## KENDAL FLOOD RISK MANAGEMENT SCHEME REVISED PLANNING APPLICATION FOR DESIGN CHANGES AT AYNAM ROAD AND WATERSIDE

## PROPOSED DESIGN CHANGES - WATERSIDE

Figure 1 – Waterside – Amended Design of Flood Alignment

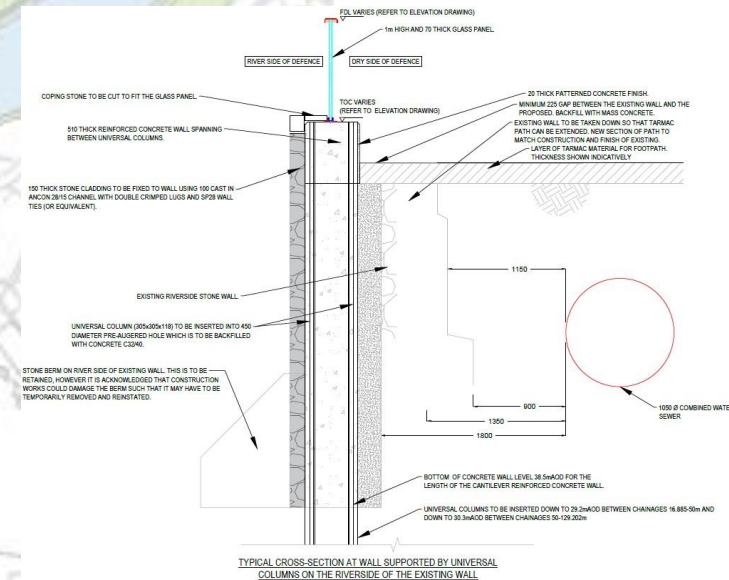
- Changes to flood defence alignment to accommodate sewer pipe, increasing the road width
- Change from L-wall to vertical wall with king posts installed at a fixed distance

# PROPOSED DESIGN CHANGES TO FLOOD WALL ALIGNMENT AT WATERSIDE (FIGURE 1)

Extension of wall by 3m to avoid conflict with water sewer pipe.

Figure 3 – Waterside – Proposed Amended Design

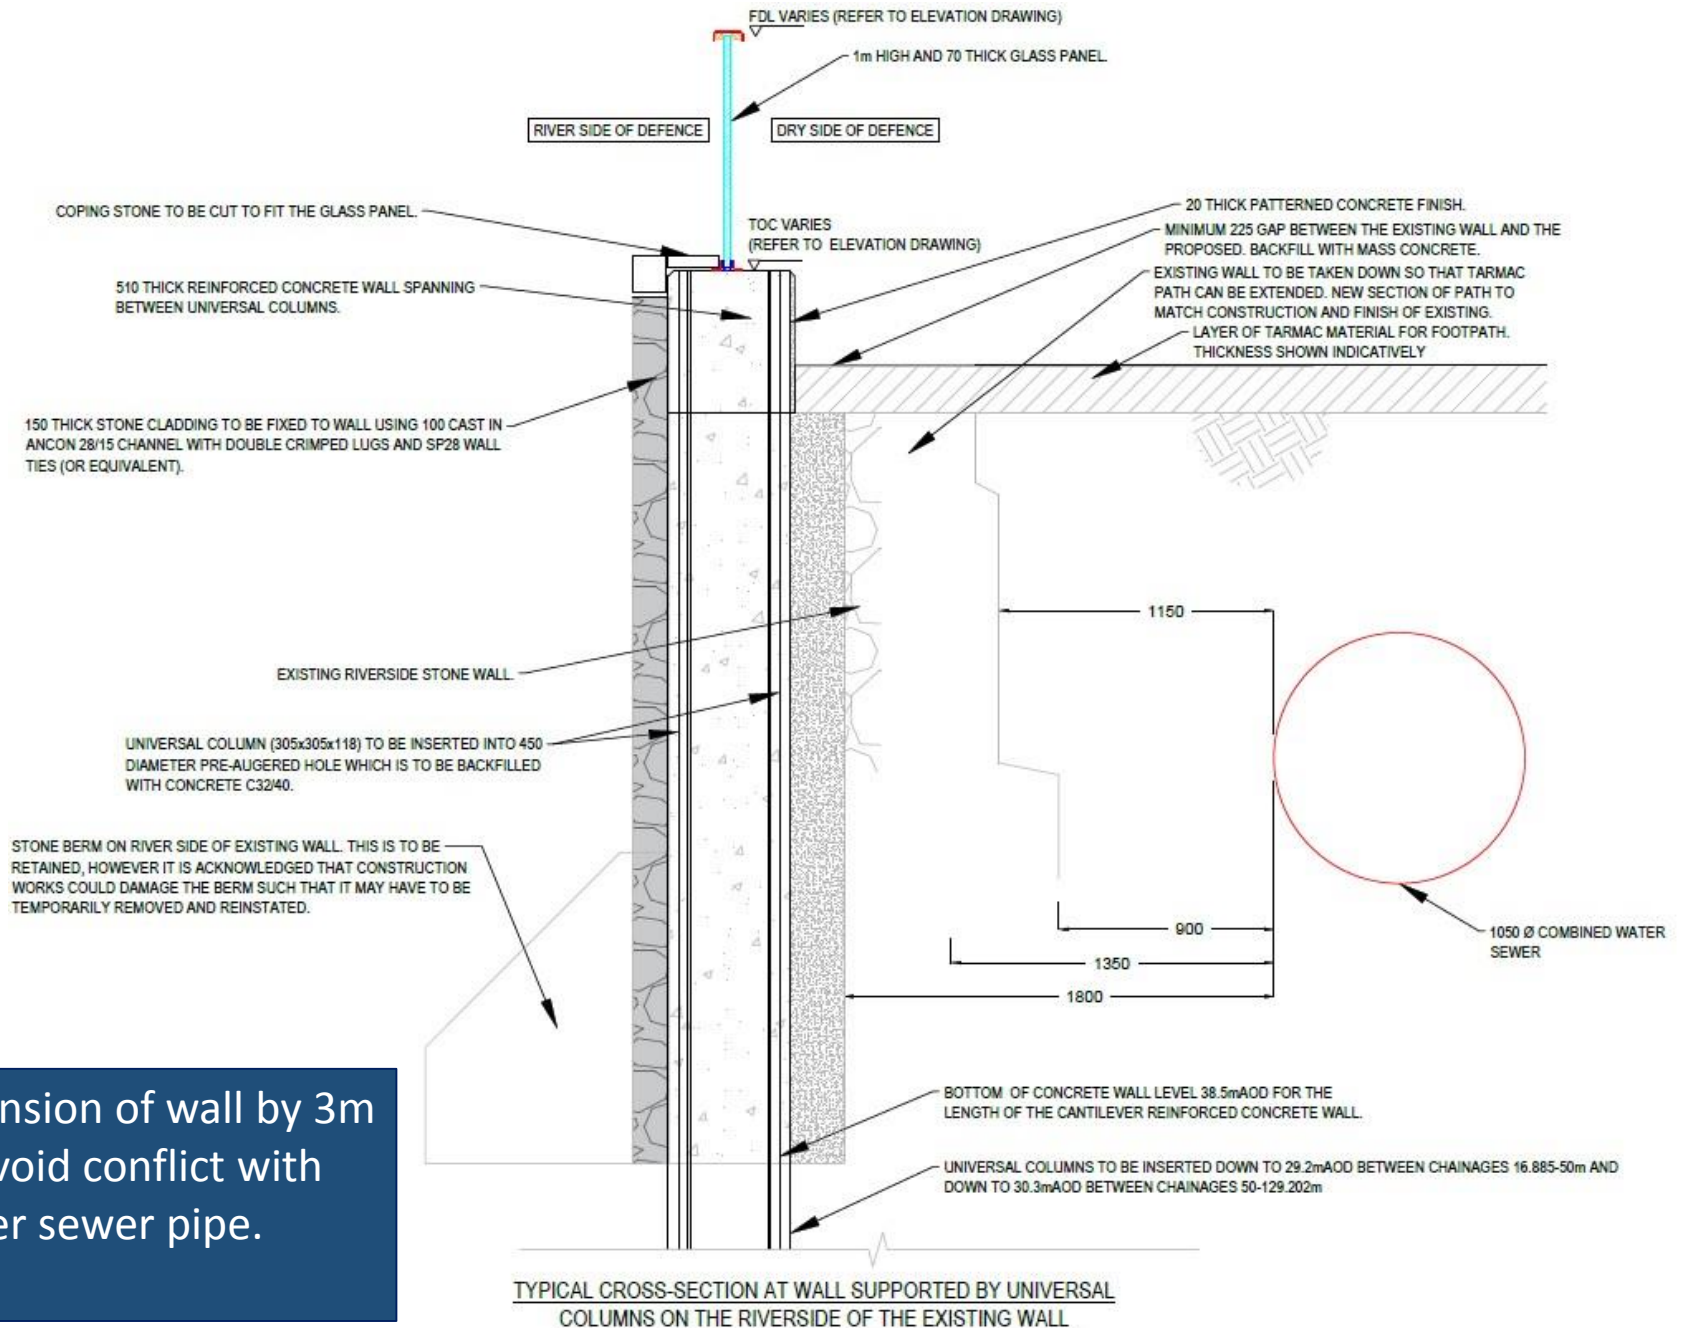
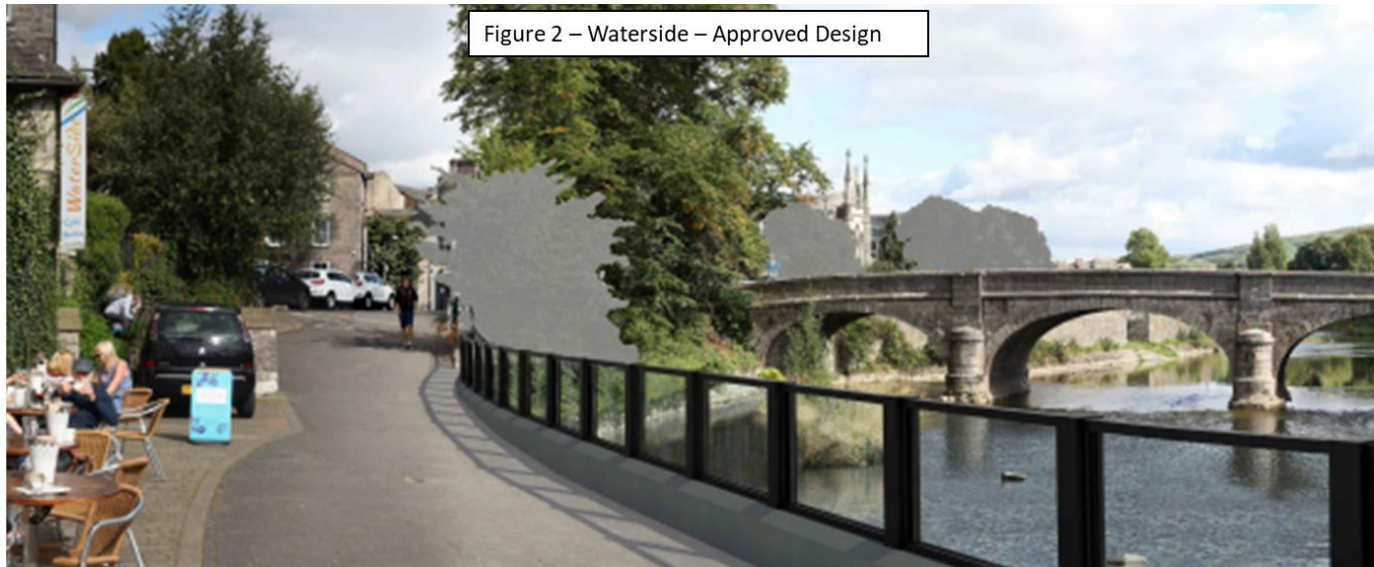
Original approved design has been improved to a slimline brushed Stainless Steel top rails and uprights, recessed bottom rails. Glass panels all 3m in length to reduce frequency of uprights and increase riverside views.

Flood gate to remain open for riverside access and closed in flood conditions.

## PROPOSED DESIGN CHANGES – USE OF KING POST PILING AT WATERSIDE

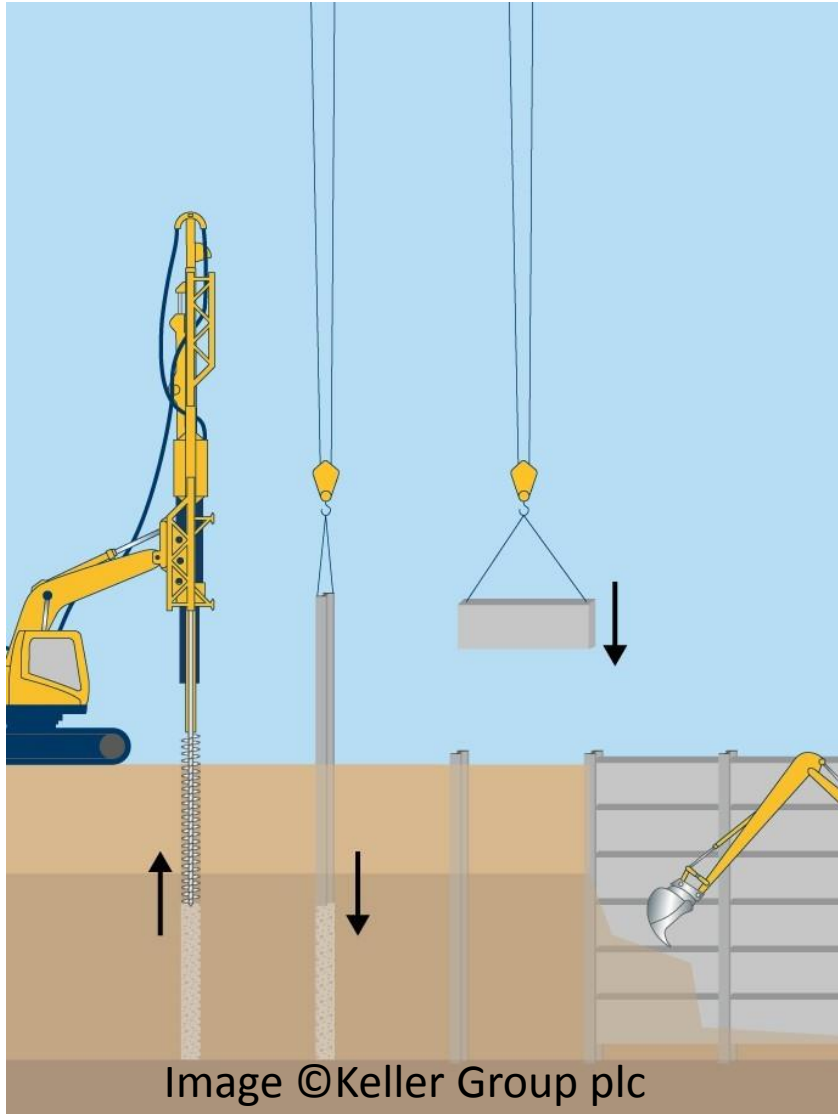
- Continuous flight auger (CFA) piling rig drills hole in the ground to provide foundation.
- 'H' shaped King post installed into auger hole and concreted in place.
- Reinforced concrete is cast between the H beams to form river retaining wall up to ground level.
- Once completed the riverside panels are faced with stone.
- Above ground level a new reinforced concrete flood wall will be built, the top 1m of which will be stainless steel framed glass panels.

## PROPOSED DESIGN CHANGES – WEBSTER RAILINGS AT MILLER BRIDGE

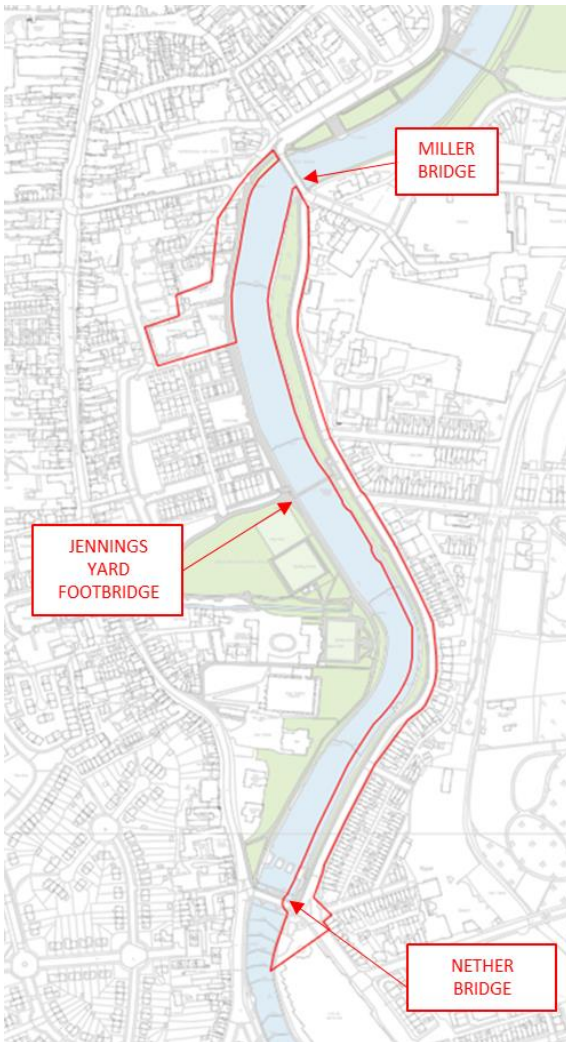
As part of the Design Amendments it is proposed to reproduce a section of Webster railings on the left bank of the River Kent, and this design will influence the railing design throughout the wider scheme.

### AYNAM ROAD NORTH

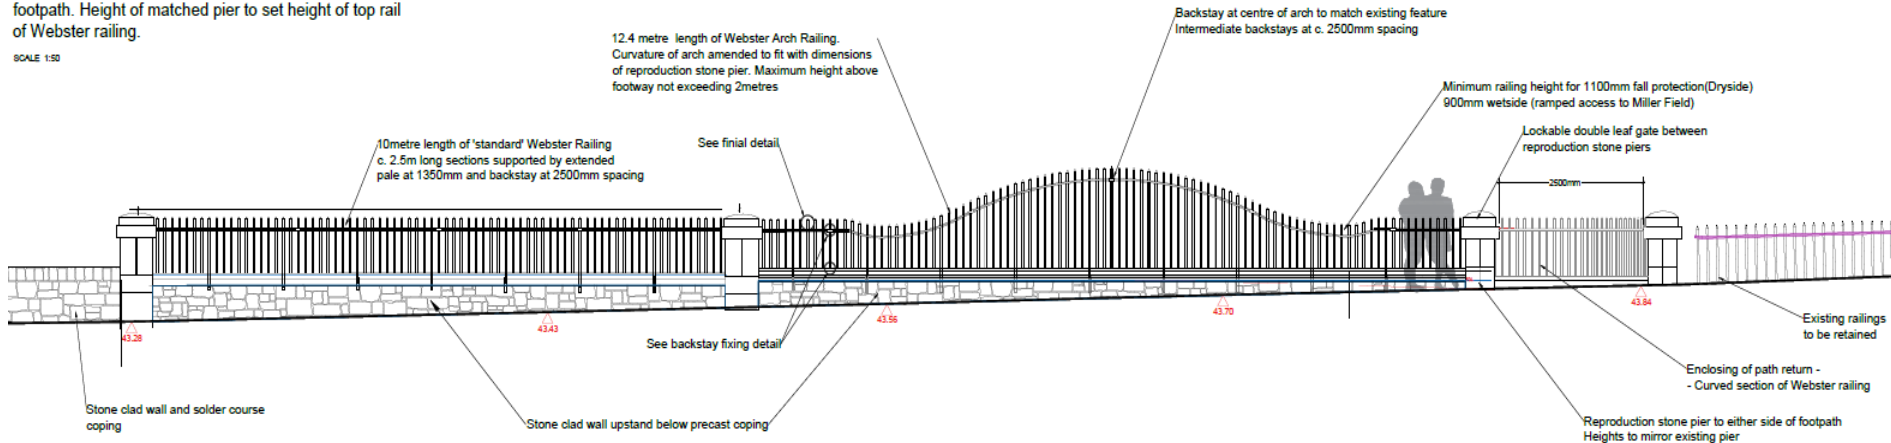
Webster Arch and Railing. Existing stone pier to be retained and replicated to form entrance to Miller Field footpath. Height of matched pier to set height of top rail of Webster railing.

## PROPOSED DESIGN CHANGES – AYNAM ROAD CENTRAL – DESIGN AMENDMENTS

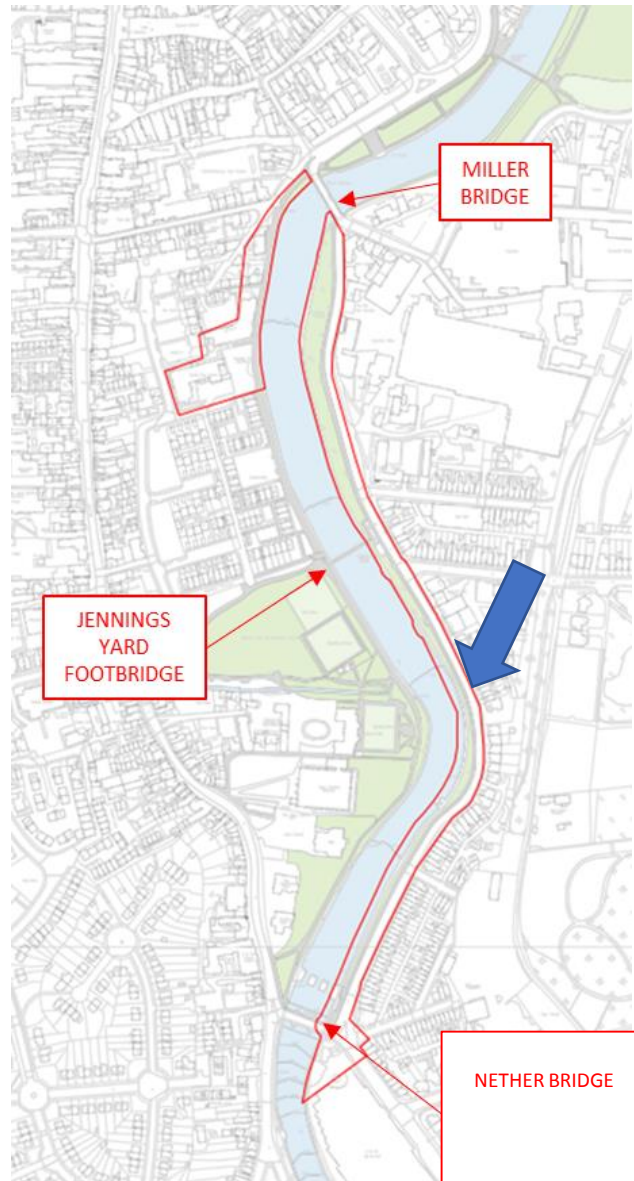
Proposed view illustrating all existing trees cleared to facilitate works with proposed glass panel fixed to low stone clad wall located at rear of the footway. Tree planting proposed where ground conditions allow (after 5 year growth).

## PROPOSED DESIGN CHANGES – AYNAM ROAD CENTRAL – DESIGN AMENDMENTS

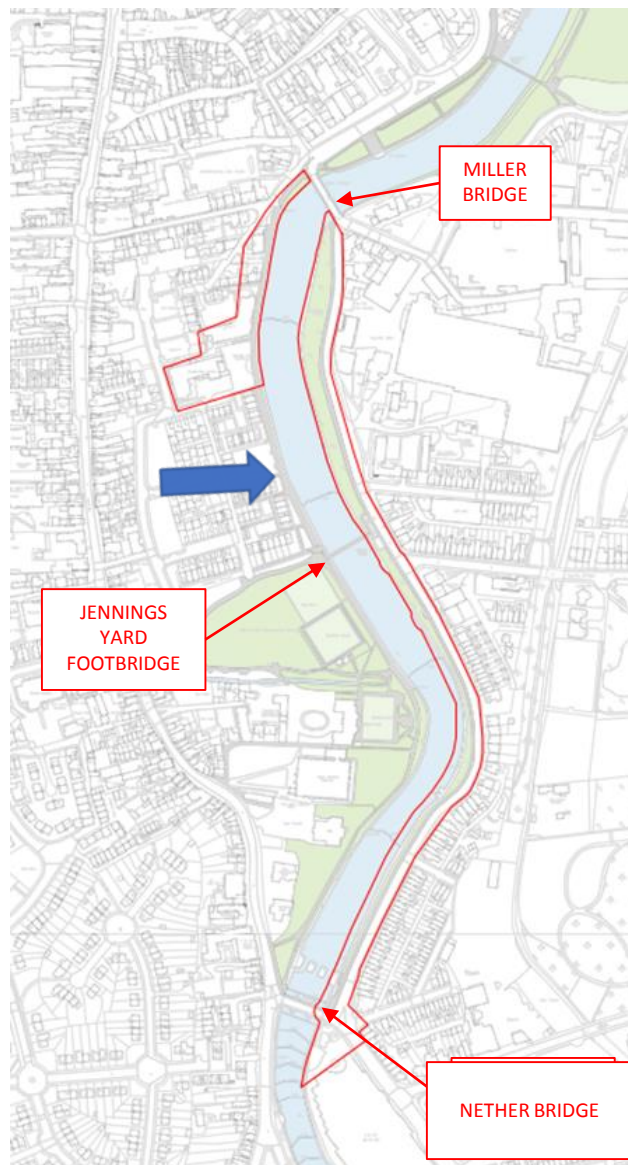
Proposed view illustrating wall mounted glass panels to rear of Miller Field, footpath, seating sculpture and Castle Mills outfall visible within view(TBC). Decorative tree planting across view (5years growth). Existing riverside vegetation on and below lower riverbank to be retained.

## PROPOSED DESIGN CHANGES – AYNAM ROAD CENTRAL – DESIGN AMENDMENTS

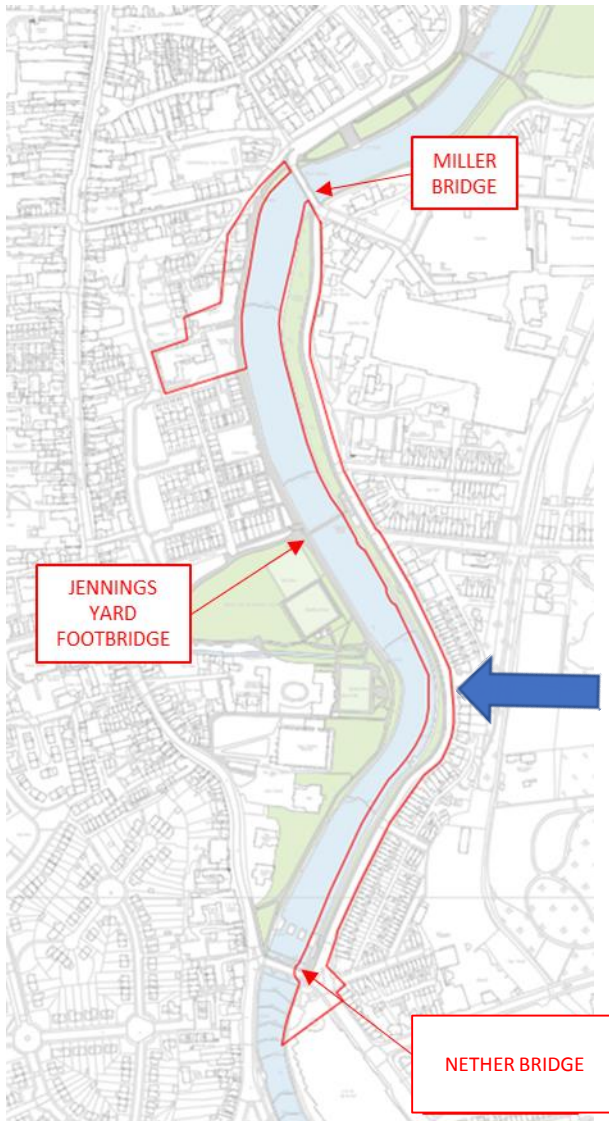
Proposed view illustrating removal of roadside trees and railing and replacement with low stone clad wall topped with glass panel flood defence

## PROPOSED DESIGN CHANGES OVERVIEW – AYNAM ROAD PILING

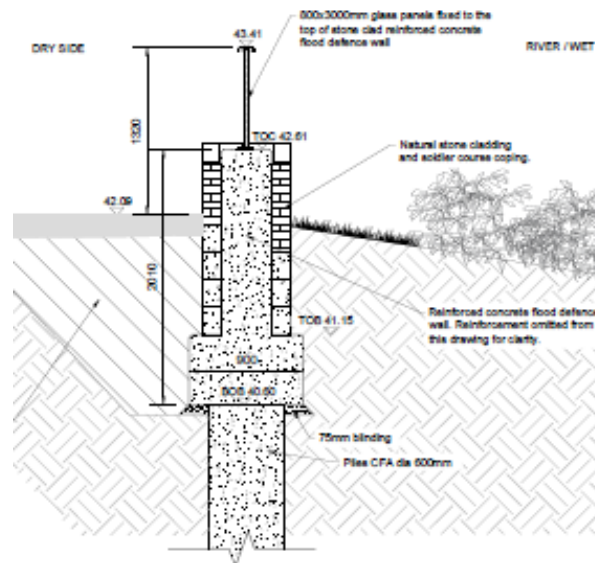
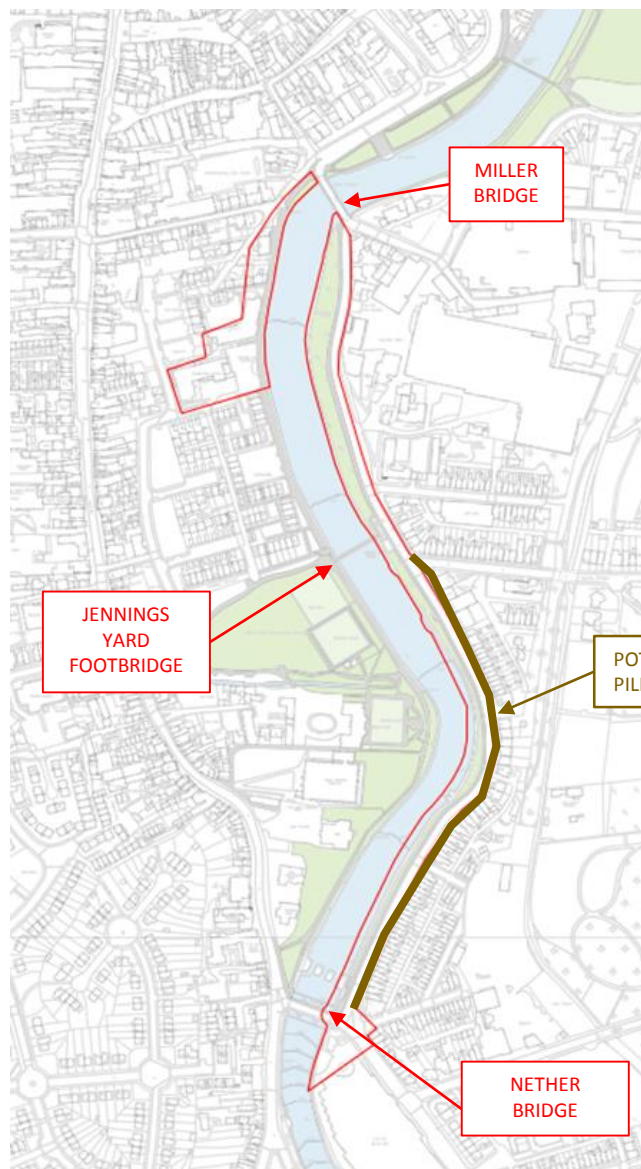
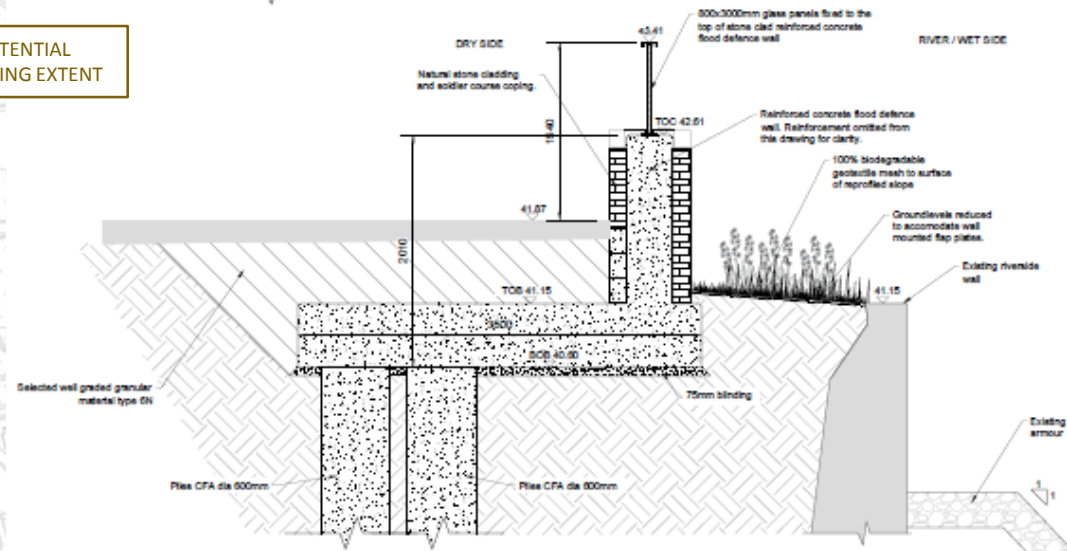
Piling used to control both seepage and groundwater when river levels are high.

Construction type varies according to ground conditions and access restrictions.
